# Access Compliance Report

## Public Rights-of-Way

Intersection ID: 45132	Main Street: FOUR SISTERS LN	Cross Street: LITTLE WHITEOAK RD	Location: SW
ADA ID: 8469E0A2DE96	Ramp Type: PerpDiag	Initial Pass/Fail: Fail	Overall Compliance: No
		Severity Score: 8.75

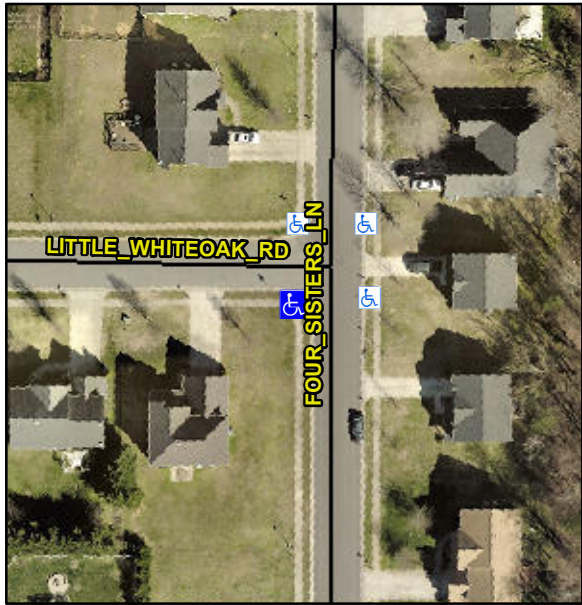
Codes/Mitigation Info/Possible Solution			Field Measurements/Component Compliance					
	Possible Solutions:		Compliance	Description	Data	Compliance	Description	Data
	Remove & Replace Curb Ramp With Two New Directional Ramps or Equivalent.		N/A	Ramp Length (in)	50.0	Yes	Ramp Slope (%)	7.5
			No	Ramp Width (in)	47.0	Yes	Ramp XSlope (%)	0.8
			N/A	Flare Type LT	N/A	N/A	Flare Type RT	N/A
			N/A	Flare Slope LT (%)	N/A	N/A	Flare Slope RT (%)	N/A
			N/A	Flare Traversable LT?	N/A	N/A	Flare Traversable RT?	N/A
			N/A	Landing Length (in)	N/A	N/A	DWS Provided?	N/A
			N/A	Landing Width (in)	N/A	N/A	DWS Contrast?	N/A
			N/A	Landing Slope (%)	N/A	N/A	DWS Length (in)	N/A
			N/A	Landing X Slope (%)	N/A	N/A	DWS Full Width?	N/A
Surveyor Notes:	N/A		N/A	Landing Curb? (Y/N)	N/A	N/A	DWS Offset (in)	N/A
			N/A	Shared Landing?	N/A			
	PROW/ADA:		N/A	Gutter Ponding?	N/A	N/A	Gutter Slope (%)	N/A
	Not Found, R304.5.1		N/A	Gutter Lip Ht (in)	N/A	N/A	Gutter X Slope (%)	N/A

N/A	Painted X Walk1?	No	N/A	Painted X Walk2?	No
				X Walk 1 Direction	To E		X Walk 2 Direction	To N
			N/A	X Walk 1 Width (in)	N/A	N/A	X Walk 2 Width (in)	N/A
				X Walk 1 Slope (%)	2.5		X Walk 2 Slope (%)	2.4
				X Walk 1 X Slope (%)	1.3		X Walk 2 X Slope (%)	1.6
			N/A	Ramp inside XWalk1?	N/A	N/A	Ramp inside XWalk2?	N/A
Total Cost:				Road Slope (%)	0.3	N/A	Clear Space?	N/A
				Road X Slope (%)	3.4	N/A	Clear Space to XWalk (in)	N/A
			N/A	Any Obstructions?	N/A	N/A	Storm Grate/Utility Hazard?	N/A
				Obstruction Type			Storm Grate/Utility Type	
					N/A			N/A
						Yes	Surface Condition? (G/P)	Good
